## OAK POINT TRANSMISSION LINE AND SUBSTATION PROJECT

**RE: Proposed Oak Point Transmission Line and Substation Project  
Denton County, Texas  
TPWD Project 34767**

# **Application for a Certificate of Convenience and Necessity**

**Public Utility Commission of Texas Docket No. 45170**

# Regional Ecosystem Framework: VEIL Composite

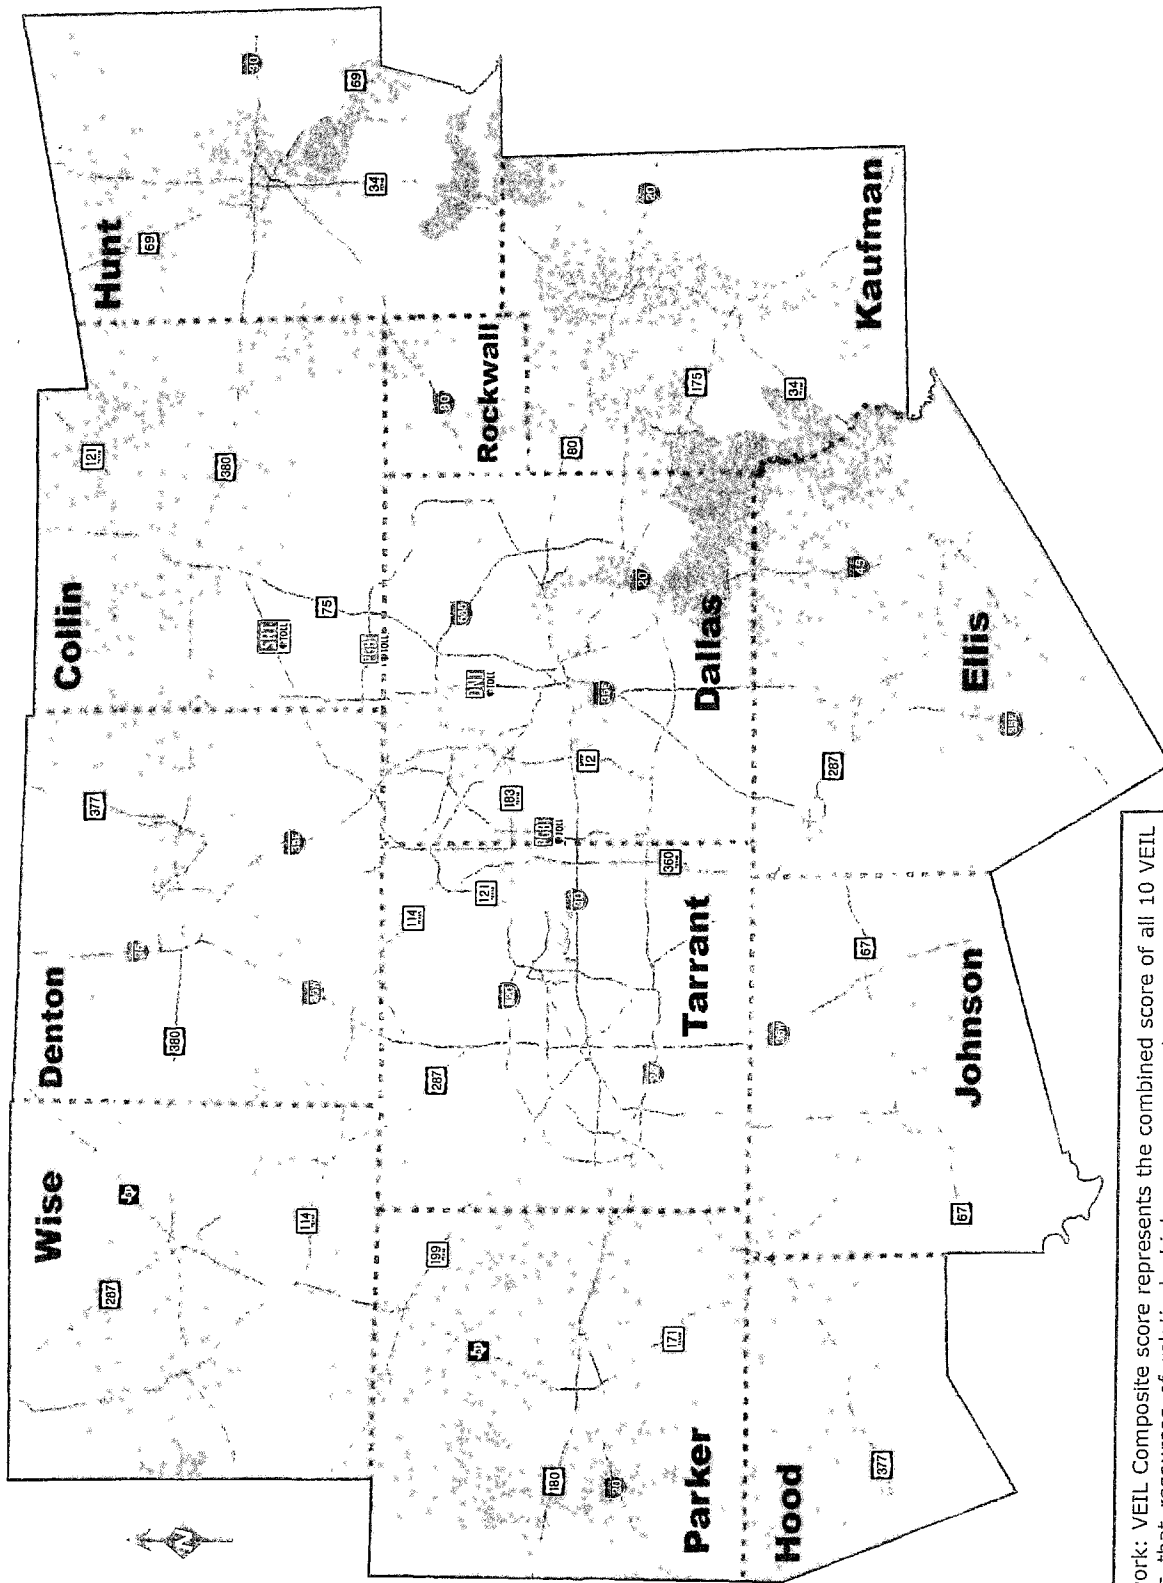
The North Central Texas Council of Governments (NCTCOG) has prepared the following comments related to the Brazos Electric Power Cooperative, Inc. (BEPC) route study and environmental report for Rural Utilities Service and the Public Utility Commission of Texas. The construction of a new transmission line and substation in Denton County was reviewed using the NCTCOG Regional Ecosystem Framework (REF). The REF is a geographic information systems (GIS) based tool that takes into account 10 Vital Ecosystem Information Layers (VEIL) used to identify ecosystem conservation priorities during development of infrastructure projects in North Central Texas. Each REF layer is based on 12-digit hydrologic unit code (HUC) subwatersheds. More information about the REF can be found at [www.nctcog.org/ref](http://www.nctcog.org/ref). The REF provides a relative indicator of the quantity of certain natural resources, but does not provide information about the quality of resources present in subwatersheds.

The quantity of a resource is important to consider when evaluating potential impacts, avoidance alternatives, and conservation opportunities. The proposed route for the transmission line and substation is located in 2 subwatersheds, Running Branch and Pecan Creek near the Little Elm Reservoir as shown in Attachment 1. Based on the REF, the Running Branch subwatershed composite score is 26 (relative to a < 15 – 40 range), which means from the composite of the 10 REF layers, resources of concern do exist when compared to other subwatersheds in the 12-county Metropolitan Planning Area. In the Running Branch subwatershed, 3 criteria were noted to be of greater priority (scoring a 5 on a scale of 1 to 5): surface water density; vegetative and species rarity; and wildlife habitat. The Pecan Creek subwatershed composite score is 22 and only 1 criteria, species rarity, scored a 5.

The REF demonstrates that these 2 subwatersheds may have some important resources to consider or study further. The REF is intended to be used as a high-level planning resource and the REF subwatershed scores are provided to assist with evaluating subwatersheds from a regional perspective and to compare their natural resource attributes to other subwatersheds in the region. The subwatershed scores and priority criteria should be considered a guide when determining potential impacts.
